**SUBJECT: NEW VEHICLE DEMONSTRATION / DELIVERY HOLD - Safety Recall 18S24  
 - Supplement #2**  
 Certain 2012-2015 Model Year Focus Electric and 2013-2015 Model Year C-MAX Energi and Fusion Energi Vehicles  
 Convenience Charge Cord Replacement

**New! REASON FOR THIS SUPPLEMENT**

*Technical Instructions: Revised to provide direction for 2013 - 2014 Model Year Ford Focus Electric vehicles with a 1<sup>st</sup> generation tire mobility kit.*

**FIGURE 7**

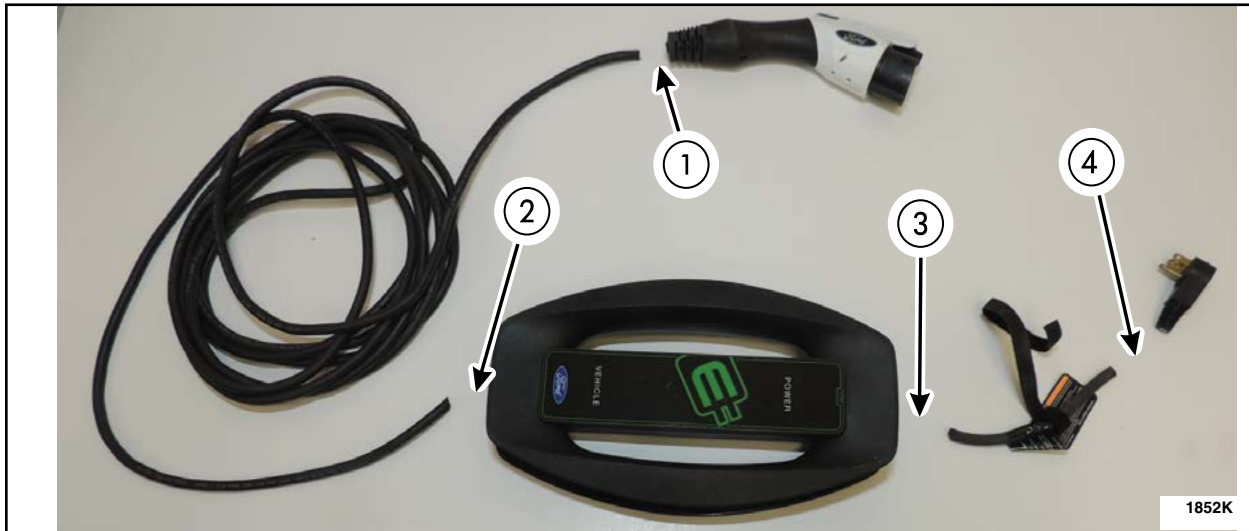
6. For vehicles with the first generation tire mobility kit, remove the convenience charge cord and install the new convenience charge cord into the existing foam insert.

**NOTE:** The new convenience charge cord may be wrapped end to end around the power supply as shown in Figure 7 avoiding interference to the tire mobility kit.
